MEMORANDUM **Case # 17-08**

TO: MAG Specifications and Details Committee Members

SUBJECT: Proposed Revisions to Curb Ramp Series Details 236 & 237, and Section 340. New Series 238 Details and removal of Details 235-1, 2, & 3. **REVISED**

Purpose: Revisions to current curb ramp details to not imply diagonal usage for new construction (PROWAG) yet still provide various ramp styles needed for different situations. Other revisions include consistency in drafting, construction notes and standard naming terminology for curb ramps: perpendicular, parallel and combination (both parallel and perpendicular aspects). Efforts here are as discussed in ADA Working Group.

DETAIL NO.				
236-1	MARICOPA ASSOCIATION of GOVERNMENTS — STANDARD DETAIL ENGLISH	25' - 35' R - RADIAL CURB RAMP ATTACHED SIDEWALK	DRAFT 07–25–2017	DETAIL NO. 236-1

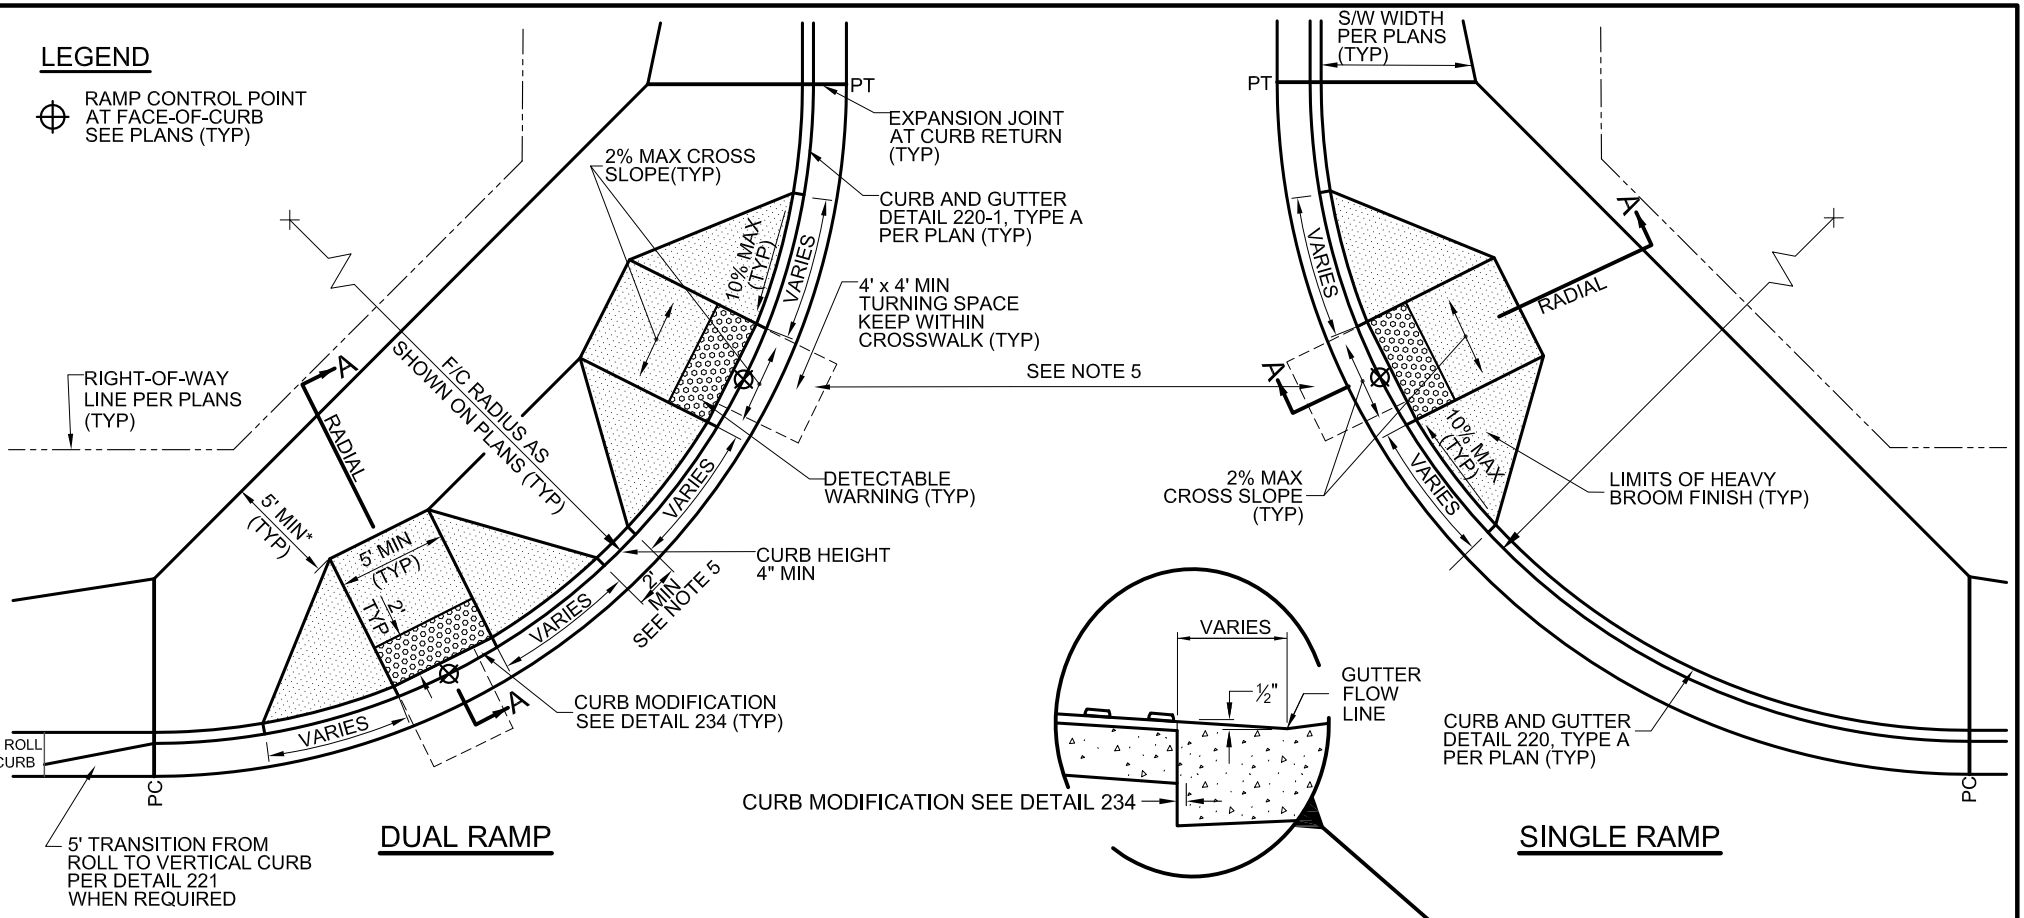
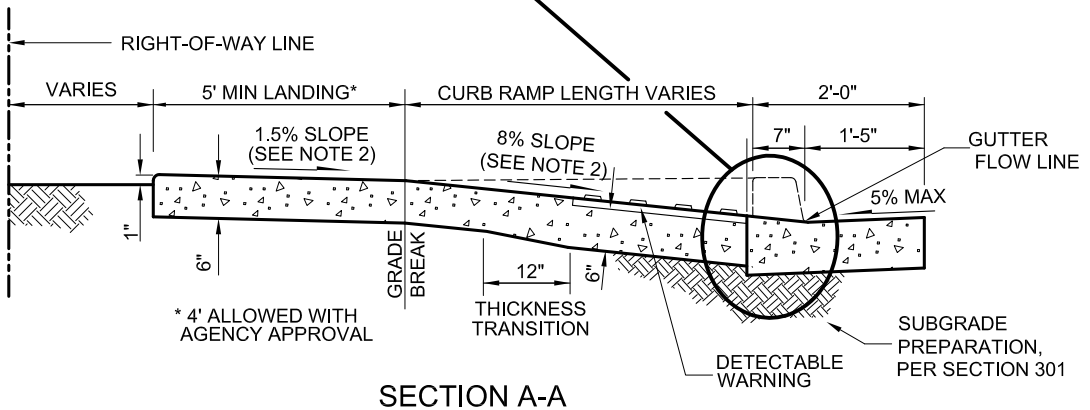
- Revised 236 and 237 Ramp Details – changed cross slope note shown within ramp and landing to “2% MAX CROSS SLOPE (TYP)”, revised note to “4 ROLL CURB”.
- Revised Note 2 on all details removing word “EXPANSION”.
- Revised 236 Ramp Details - cut lines extend through the curb directional rather than perpendicular to the curb.
- Revised 236-1, 236-2, 237-1, 237-2 and 238 Ramp Details – changed landing callout to “5’ MIN (TYP)*” and added “* 4’ ALLOWED WITH AGENCY APPROVAL”.
- Revised 237-3 Detail – ramp flares shown to meet the PC/PT.
- Revised 236-1 Detail – changed curb height between ramps to “CURB HEIGHT 4” MIN” and added potential grade break line connecting ramp landings.
- Revised 238 Ramp Details – changed concrete class back to ‘B’ in Note 1.
- Adding proposed revisions to Section 340 per comments from Bob Herz.
